POLICY ISSUE **(Information)**

SECY-85-384

SUBJECT: DESIGN ADEQUACY OF THE AUXILIARY PRESSURIZER SPRAY
SYSTEM AT PALO VERDE NUCLEAR GENERATING STATION

II.C. AUXILIARY PRESSURIZER SPRAY SYSTEM (APSS)

SIMPLIFIED SCHEMATIC OF PALO VERDE CVCS SHOWING AUXILIARY SPRAY PORTION

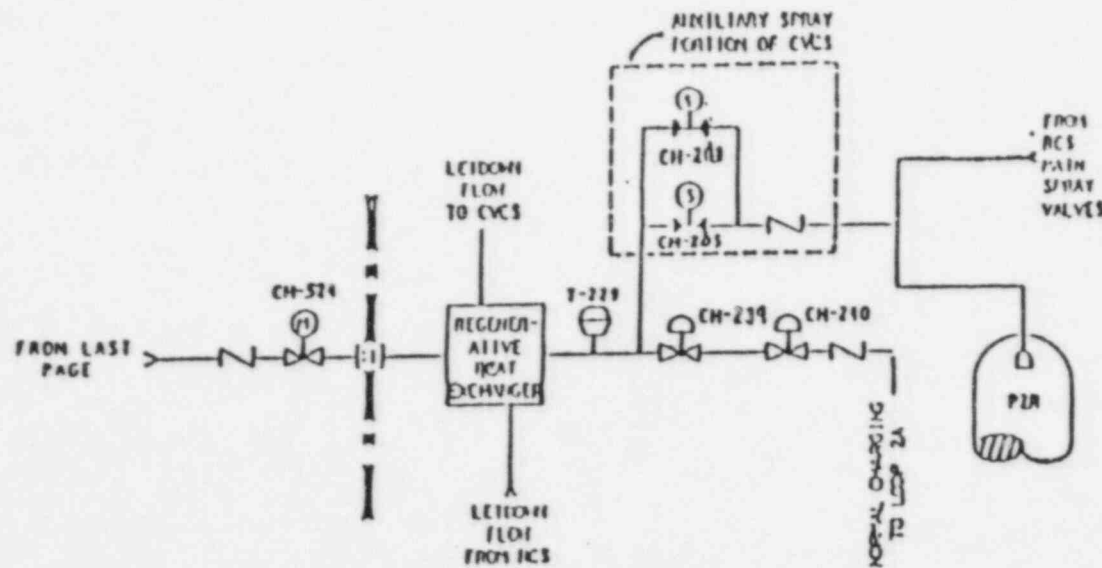
1. The Palo Verde design includes a safety grade auxiliary pressurizer spray system. As a result of the September 12, 1985 event at Palo Verde Unit 1, it is our view that the auxiliary pressurizer spray system does not meet safety grade standards and that the Palo Verde design is not consistent with the docketed information describing the system design. Therefore, describe the design modifications APSS intends to make to upgrade the auxiliary spray system to safety grade standards and provide the schedule by which this effort will be accomplished.

2. The auxiliary spray system was stated to be safety grade on the Palo Verde docket and then later determined to have single failure vulnerabilities and other deficiencies. Provide a detailed explanation of how the QA process, which should include an independent review and verification of design adequacy, did not detect these deficiencies in the auxiliary spray system. Also provide a description of the corrective actions APSS intends to take to remedy any weaknesses identified in the QA process.

3. Provide a detailed description of what APSS considers to be safety grade design requirements and how these requirements are applied to systems and components that are specified as safety related. In particular, discuss how these requirements were applied to the auxiliary spray system and whether the identified deficiencies in auxiliary spray system were due to a failure to apply them to the system.

- ADD SECOND, DIVERSE REFERENCE LEG TO VCT LEVEL TRANSMITTERS
 - ADDRESSES ROOT CAUSE OF LOSS OF CHARGING EVENT
 - REPLACES NEED FOR DAILY REFERENCE LEG CHECK

- PROVIDE POWER TO VCT OUTLET AND RWT GRAVITY FEED LINE VALVE FROM 1E MCC
 - ELIMINATES NEED TO MANUALLY RESTORE POWER TO THE VALVES FROM OUTSIDE THE CONTROL ROOM FOLLOWING AN SIAS

- ADD AUTOMATIC ACTUATION TO GRAVITY FEED LINE VALVE
 - ELIMINATES THE NEED TO MANUALLY OPERATE THE GRAVITY FEED LINE VALVE FROM THE CONTROL ROOM DURING LOSS OF OFFSITE POWER CONDITIONS

- LOCK OPEN TWO NORMALLY OPEN VALVES IN AUXILIARY SPRAY FLOW PATH
 - ELIMINATES POTENTIAL FOR ISOLATION OF GRAVITY FEED OR CHARGING LINE DUE TO SPURIOUS ACTUATION OR OPERATOR ERROR

COMPARISON OF THE RCS PRESSURE RESPONSE FOLLOWING A SGTR
WITH AUX SPRAY INITIATED AT 1015 SECONDS vs 2 HOURS

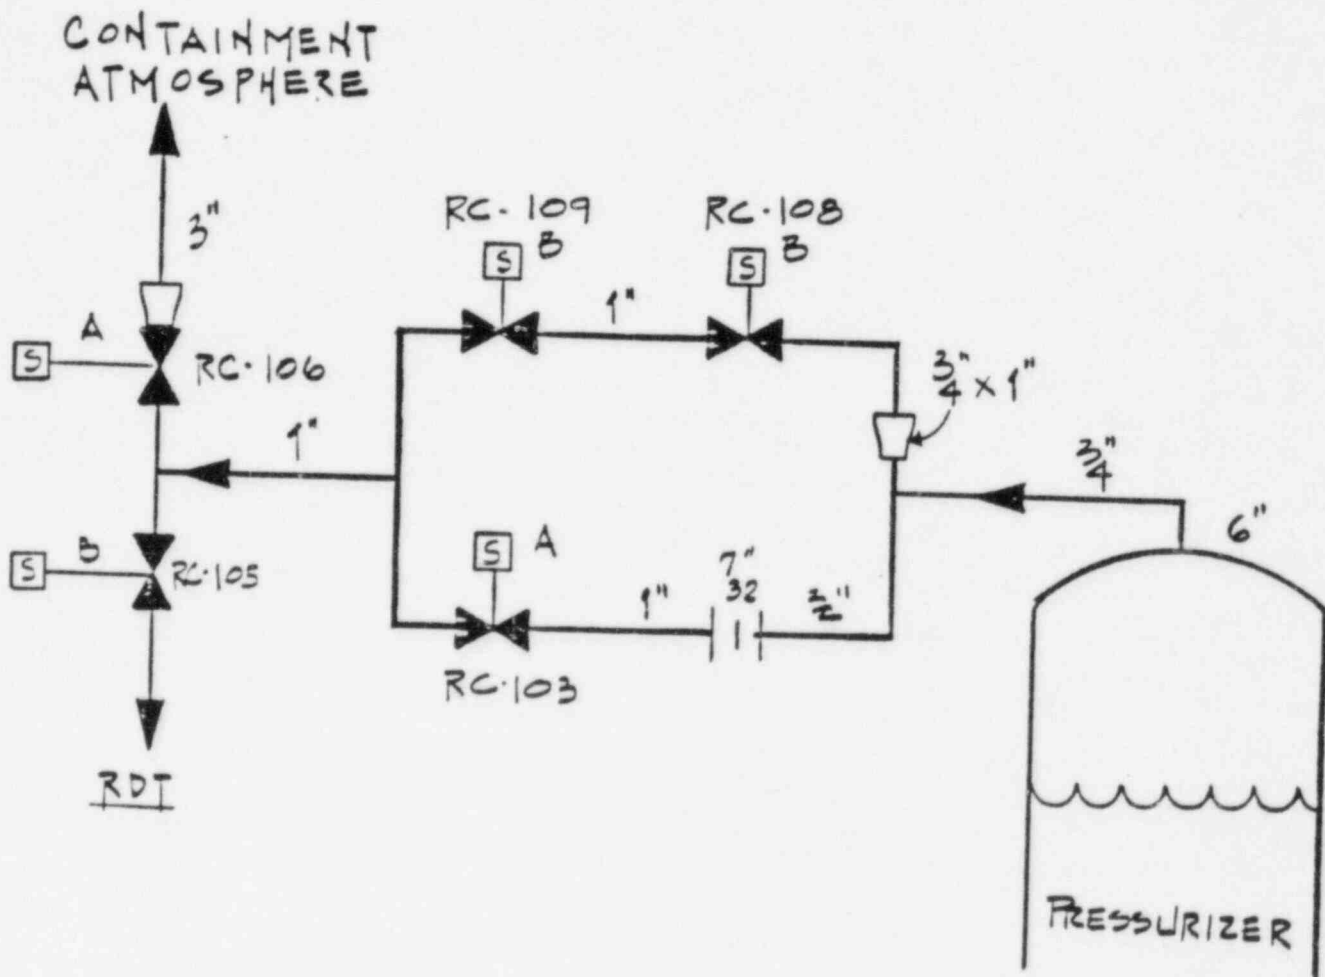
- EXPLAIN THE USE OF AUXILIARY PRESSURIZER SPRAY IN THE PALO VERDE STEAM GENERATOR TUBE RUPTURE ANALYSIS
- DEMONSTRATE THAT THE DOSE CONSEQUENCES FOR THE PALO VERDE SGTR ANALYSIS ARE RELATIVELY INSENSITIVE TO THE TIME AUXILIARY PRESSURIZER SPRAY IS INITIATED
- SHOW THAT AN ALTERNATIVE SYSTEM EXISTS TO FACILITATE DEPRESSURIZATION FOLLOWING A STEAM GENERATOR TUBE RUPTURE

- ° DOSE RESULTS ARE RELATIVELY INSENSITIVE TO THE TIME OF AUXILIARY PRESSURIZER SPRAY ACTUATION DURING THE FIRST TWO HOURS
- ° 100CFR100 DOSE LIMITS ARE NOT EXCEEDED WHEN APSS USE IS DELAYED UNTIL TWO HOURS AFTER THE EVENT INITIATION
- ° AN ALTERNATE SYSTEM EXISTS THAT CAN BE USED TO FACILITATE DEPRESSURIZATION DURING A STEAM GENERATOR TUBE RUPTURE, WITH NO IMPACT ON THE DOSE CONSEQUENCES.
